3404 East Harmony Road Fort Collins, CO 80528-9599 PATENT APPLICATION

Attorney Docket No: 10004251-3

AMENDMENTS TO THE DRAWING

REMARKS

Fig. 6b

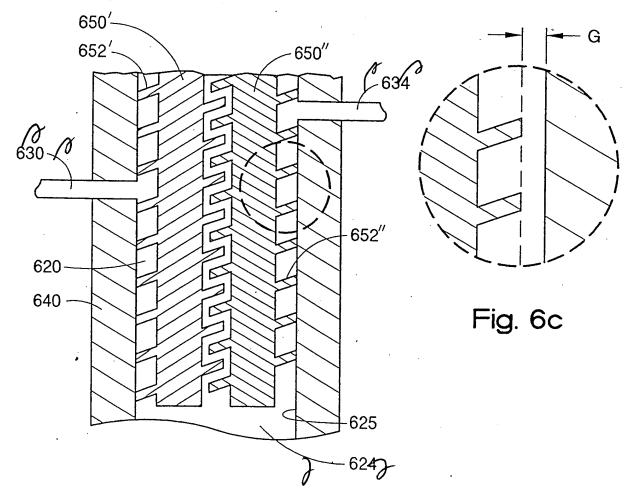
The attached drawing sheet includes a proposed change to Fig. 6b.

Examiner has objected to the drawings under 37 C.F.R. §1.78(a)(2) and (a)(5) for failing to show elements 624, 630, and 634 as described in the specification. However, upon reviewing the specification and drawings, Applicant finds that the specification fails to mention every reference character shown in Fig. 6b in non-compliance with 37 C.F.R §1.84(p)(5). In response Applicant has proposed amending Fig. 6b by deleting the numerals 624, 630, 634, and their corresponding lead lines from the figure.

In Fig. 6b, the numerals 624, 630, 634, and their corresponding lead lines have been deleted from the figure.
